Eastside Road Storage Project Final Supplemental Environmental Impact Report

Prepared for
Town of Windsor, California

October 2008

FIGURE 2-5
Storage Pond Construction Plan

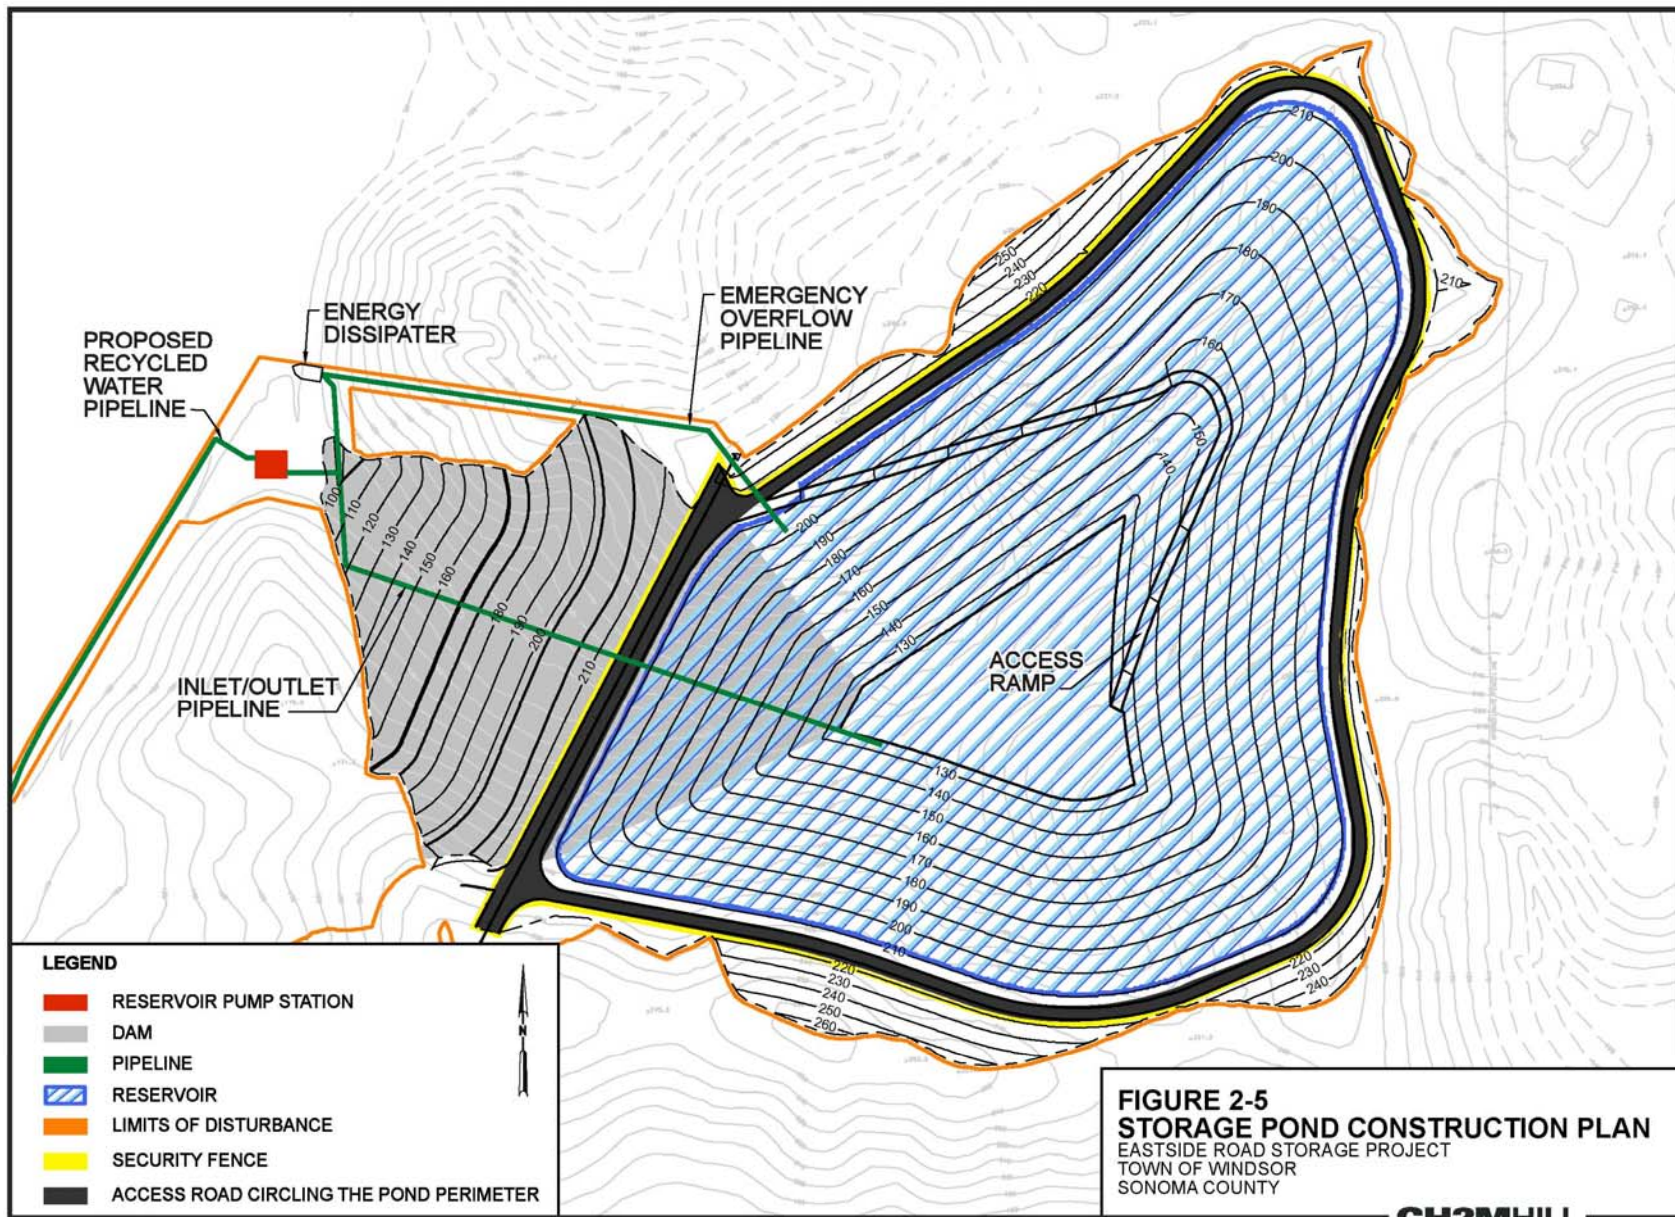
- 3-5a 2.4.1 Storage Pond. The pond description should include the Town Council's direction that the project shall include landscape screening to reduce the project's visual impact. The Storage Pond Facilities figure (Figure 2-5) should show that this landscaping will be located in the northeast corner of the project site. The current landscape plan associated with the project is limited to the pump house only.

Finally, the simulated slope on the north side of the dam appears to be incorrect. Figure 2-5 indicates that a berm will run at elevation 230 + for a distance before it catches the slope cut into the knoll on the north side of the pond. The contour labels across the face of this slope are incorrectly labeled in Figure 2-6. They should be increasing from 210 to 250 feet as the slope rises from the road to the top of the knoll.

This comment is directed towards Figure 2-6, which does not exist in the Draft SEIR. The Town assumes that the comment is regarding Figure 2-5. The commentor is correct. The contour labels for the cut slope above the perimeter access road, on the northwest side of the pond, were incorrectly drawn and have been changed to show the correct elevation range of 220 to 250 feet above sea level (see Chapter 3, Revisions to the Draft SEIR).

Figure 2-5 indicates a cut slope, rather than a berm, across the north side of the pond. The commentor is correct about the mislabeled contours at the knoll on the north side of the pond – they should be decreasing in elevation as the commentor states. Section 3.0 of this Final SEIR contains a corrected Figure 2-5. The visual simulations are accurate – they follow the correct contours at the knoll from the preliminary design drawings and not the mislabeled contours on the figure. Note: the Town assumes the commentor intended to refer to Figure 2-5 – there is no Figure 2-6.

Figure 2-5, Storage Pond Construction Plan (p. 2-23) is revised to correct topographic line elevations.
